**Reference:** Planning Application Number WSCC/007/24 – Installation of Integrated Constructed Wetlands (ICW) and associated infrastructure at land adjacent to Staplefield Wastewater Treatment Works (WTW)

We write in regards the Southern Water planning application WSCC/007/24, which we object to. We have concerns in the application, which are listed in A.1, A2. & B. 1. to B.10 below.

## **A.2**

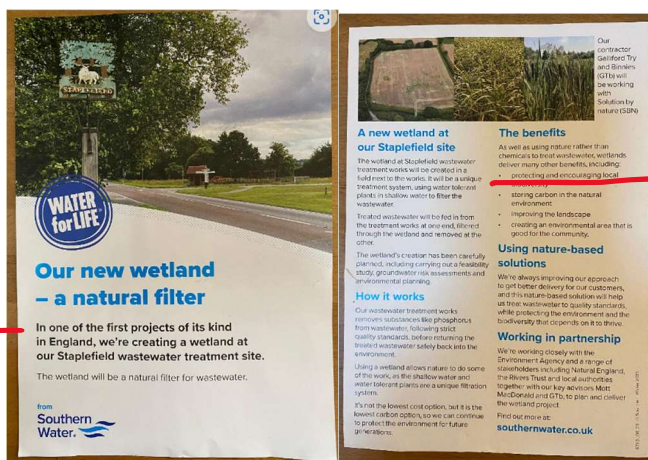
- There is a multitude of information largely based on the construction and long-term environmental impact, which is minimal. Everything is about the reed beds and the field. No information is available and can be found about the changes to the existing Staplefield WTW. Why not? What are they? There must be some needed. This needs to be addressed.

- There are no elevation or footprint details concerning the MCC and pump other than the flow is 4 l/s. Why not? It needs to be understood and what the impact is e.g. will there be a kiosk? This needs to be addressed.

- Southern Water should have commented about pump noise and any change of odour in their report. They have not, why not? This needs to be addressed.
- Operationally what happens if the pump fails? Are Southern Water installing a duty/standby pump arrangement? This needs to be addressed.

- If the pump fails, will Southern Water fail consent for the period of failure? This needs to be addressed.

**2. Loss of light/outlook/privacy:**

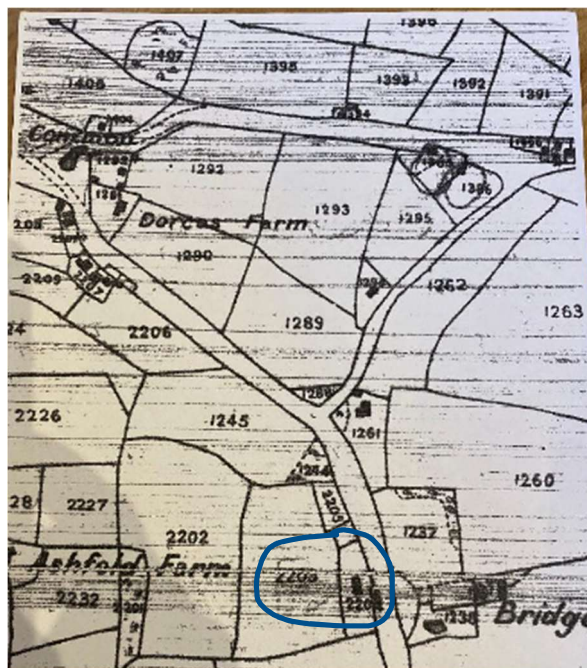
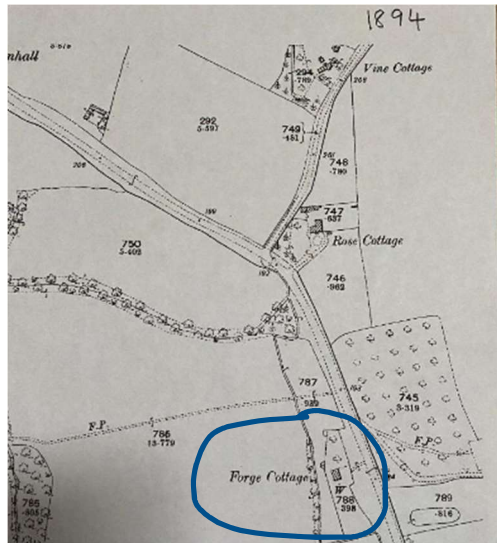
- The view south across the Ouse valley, towards Holmsted Manor RH17 5JF will be negatively changed & ruined.

The map from 1894 and the older Tithe map below show both the building & well circled in blue:

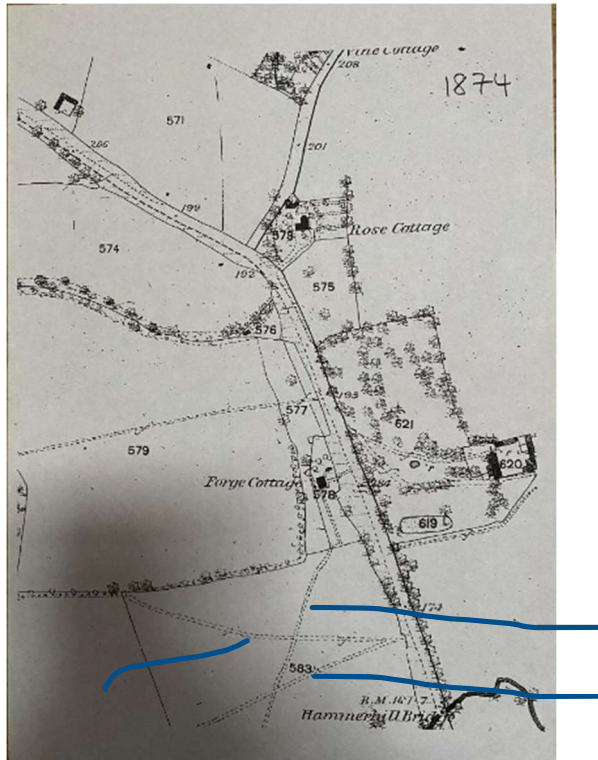
- Impact on a Grade II listed building. Chiffley Grange is grade listed II property and our curtilage is 175 metres to the north boundary of the application. It is believed the listing has not been taken into consideration appropriately.
- There was an ancient property in the field above the application called **Forge Cottage**, which is missing from the *Historic Environment Desk Based Assessment* reports. It is shown on the historic maps of 1874 & 1894 and is also shown on the Tithe map of about 1836. In addition, this property has a well (marked **W** below) which still appears to be active. In section 4.4.5 on page 20 of 51 of the same pdf it is

not mentioned. Why is that? How can it have been missed out? This needs to be addressed.

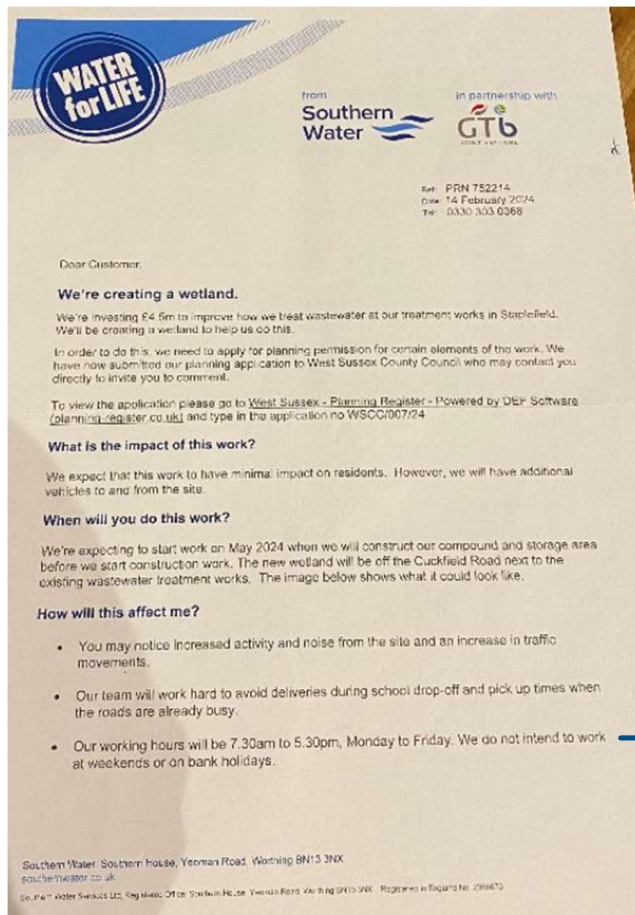
- The application field in question appears to have three ancient footpaths shown on the 1874 map below, which cross the field (pinpointed in blue). This needs to be addressed e.g. permission sought from Natural England. Also, The below map is older than the earliest one listed in the *Historic Environment Desk Based Assessment RevE Part 1.pdf*, which is 1879. Why is this?

- There is another brick-built World War II Pillbox that is missing off the *Historic Environment Desk Based Assessment RevE Part 1.pdf*. It is circled below in blue and is in the north hedge row, likely to jut into the field of the application – see the blue circle in the photo below for its position. This needs to be addressed.  
Note: It is **not** the pill box in Photo B.8
